**PROCUREMENT (SUPPLY), CONSTRUCTION, INSTALLATION/ERECTION, PRE-COMMISSIONING, & COMMISSIONING ASSISTANCE FOR NEW CENTRIFUGAL COMPRESSORS AND MODIFICATION WORKS OF EXISTING TURBO COMPRESSOR TRAINS FOR QADIRPUR COMPRESSION PROJECT**

**TENDER ENQUIRY NO. PROC-FC/CB/PROJ/QP-4369/2019  
POST-BID CLARIFICATION No. OGDCL-QP-4369-009**

Job No. 14-0106  
 Dwg. No. 0106-ELD-6705

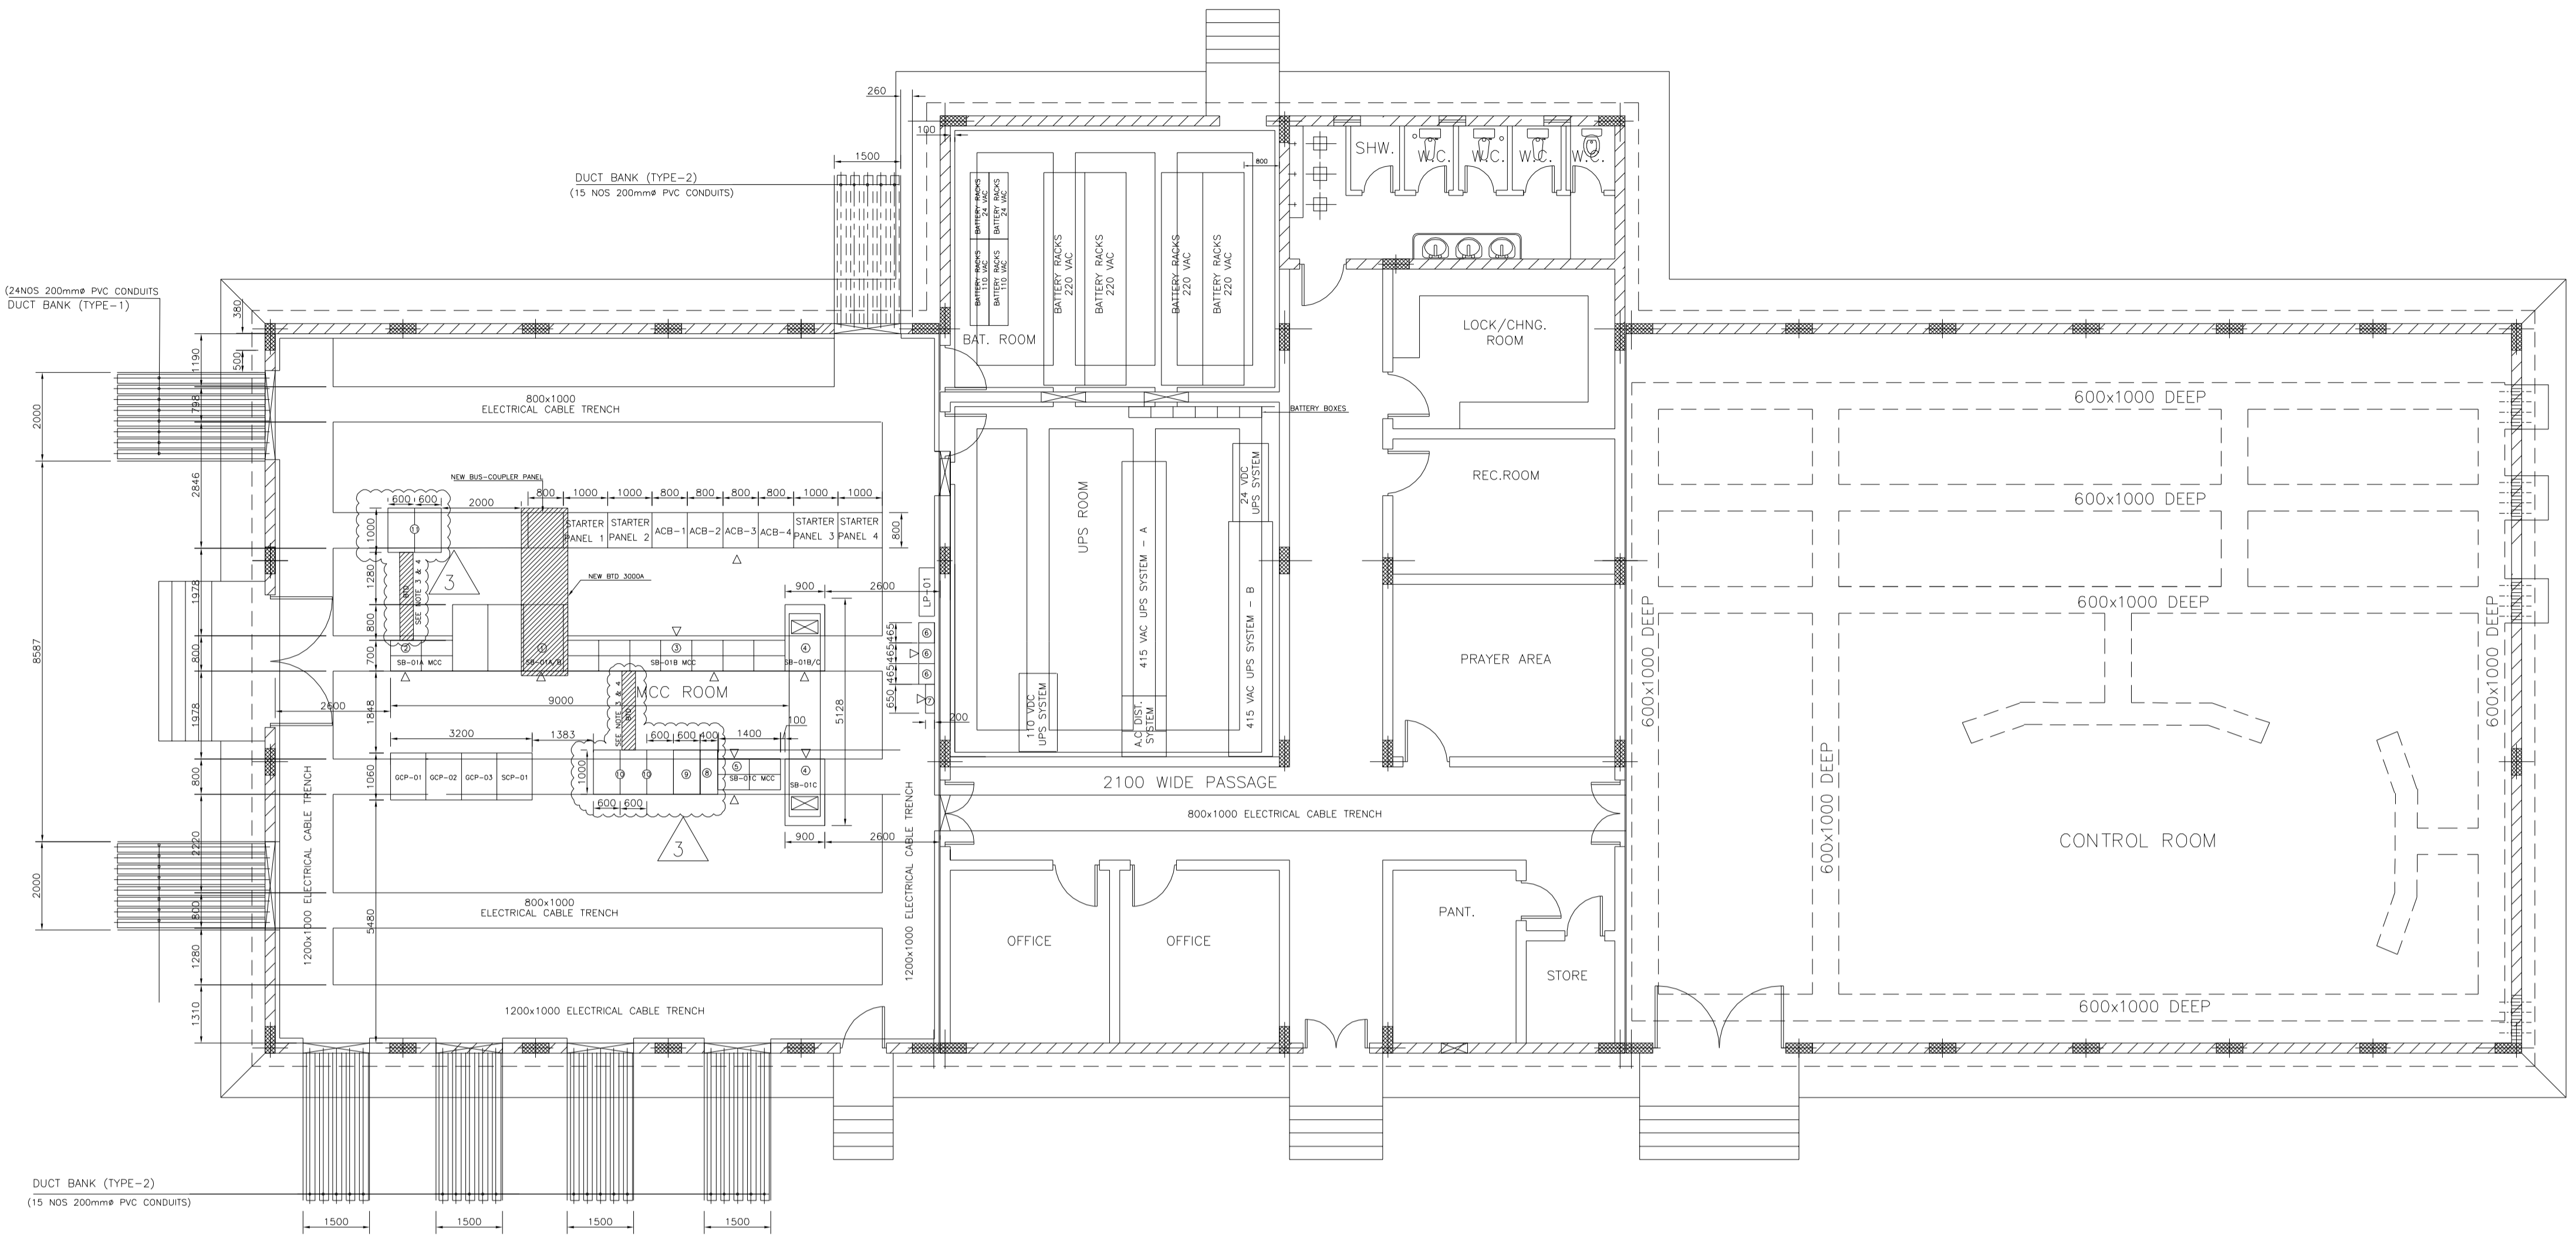
5	Please provide Switchgear room layout with placement of existing switchgears, new switchgears and BTDS.	Drawing no. 0106-ELD-6705 (MCC Room Equipment Layout) is already submitted with tender package. However, again attached here for your ready reference.
6	System study has not been mentioned in RFQ whereas it has been mentioned as vendor's scope in drawings notes. Please clarify.	Refer to Single Line Diagram Doc# 0106-ELB-6601 note#8, which states that Contractor is responsible for the selection of MCC Vendor who shall carryout following min. studies to further ascertain the values of initial and peak short circuit currents at all section of switchgear/MCC during different operation scenarios; - Load flow - Short circuit - Relay co ordination  However, short circuit rating mentioned on SLDs are minimum to consider by the bidder/vendor.
7	PCL E&I team would like to have additional site visit to further investigate the existing LV Panel modification scope, please advise the visit date so to coordinate with your site team.	Please visit web site for visit schedule.

CUSTOMERS	PIRKOH GAS FIELD COMPRESSION HYUNDAI ENG. / PAKISTAN		TITLE	OUT LINE DIAGRAM OF SB-01A MCC	
	SCALE	80290001		WORK NO	988029
LG Industrial Systems Co., Ltd.		DIMENSION	MM	3RD ANGLE PROJECTION	DWG NO
				W4-20-07199-307

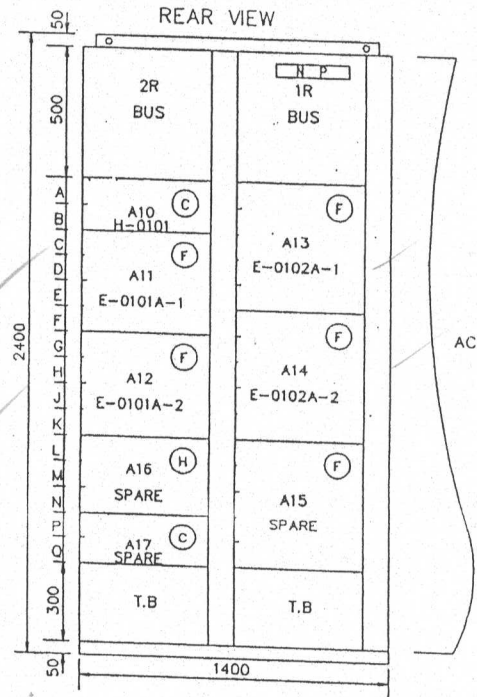
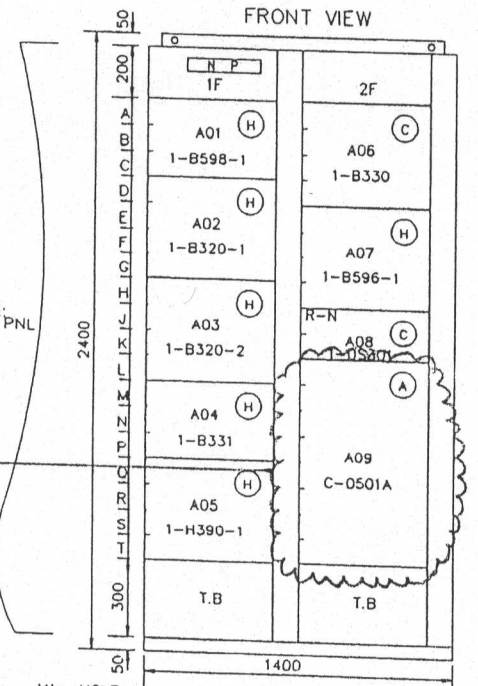
3 The starter A09 (Instrument Air Compressor) should be relocated to the rear side of SB-01B panel # 1R-A. See specification for dismantling works section 1.2
